MCDONALD'S SUBDIVISION

APPLICATION NUMBER 2 DATE March 9, 2017

DETAIL SITE PLAN

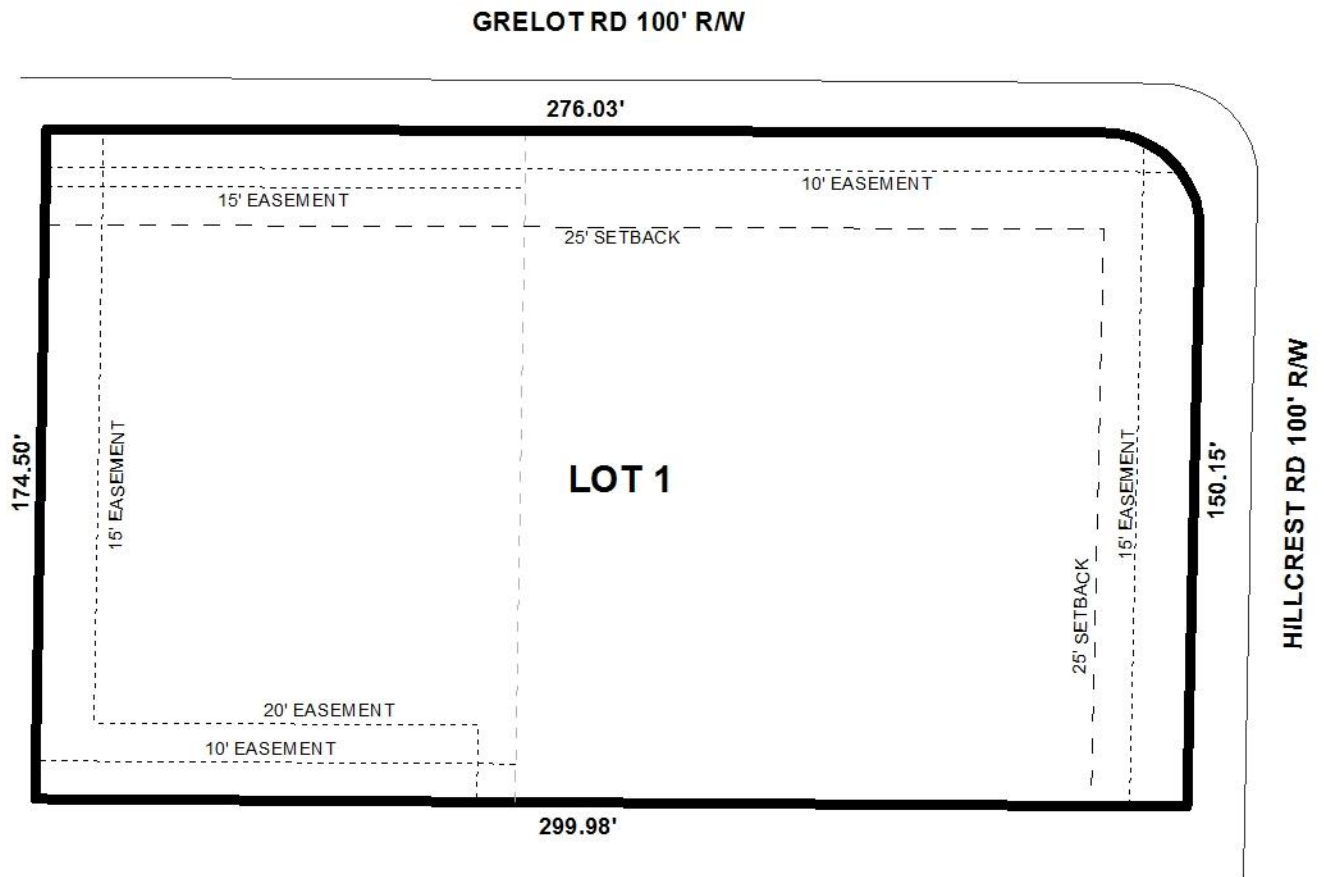
The lot meets the minimum area requirements of the Subdivision Regulations. The lot is labeled on the plat with its size in acres and a table is furnished on the plat providing the lot size in both

square feet and acres. These should be retained on the Final Plat. As on the preliminary plat, the 25' minimum building setback line should also be illustrated on the Final Plat along both street frontages.

The plat indicates various drainage, utility and slope easements on the proposed lot. These should also be shown on the Final Plat. A note should also be required on the Final Plat stating that no structure may be constructed or placed within any easements.

The plat has references to the current property zoning and side and rear setbacks. The zoning classification is subject to change and side and rear setback requirements are subject to change depending upon the zoning classification of adjacent properties. Therefore, the plat should be revised to remove the current zoning classification and references to side and rear setback requirements.

- 2) retention of the lot size label and the lot size table on the Final Plat providing the lot size in both square feet and acres;
- 3) retention of the 25' minimum building setback line along both street frontages on the Final Plat;

- 4) retention of the various drainage, utility and slope easements on the Final Plat;
- 5) placement of a note on the Final Plat stating that no structure may be constructed or placed within any easements;

- 6) revision of the plat to remove the current zoning classification and references to side and rear setback requirements;
- 7) placement of a note on the Final Plat stating that any additional site improvements of the proposed lot are subject to the acquisition of the appropriate permits, and should comply with all applicable codes and ordinances;
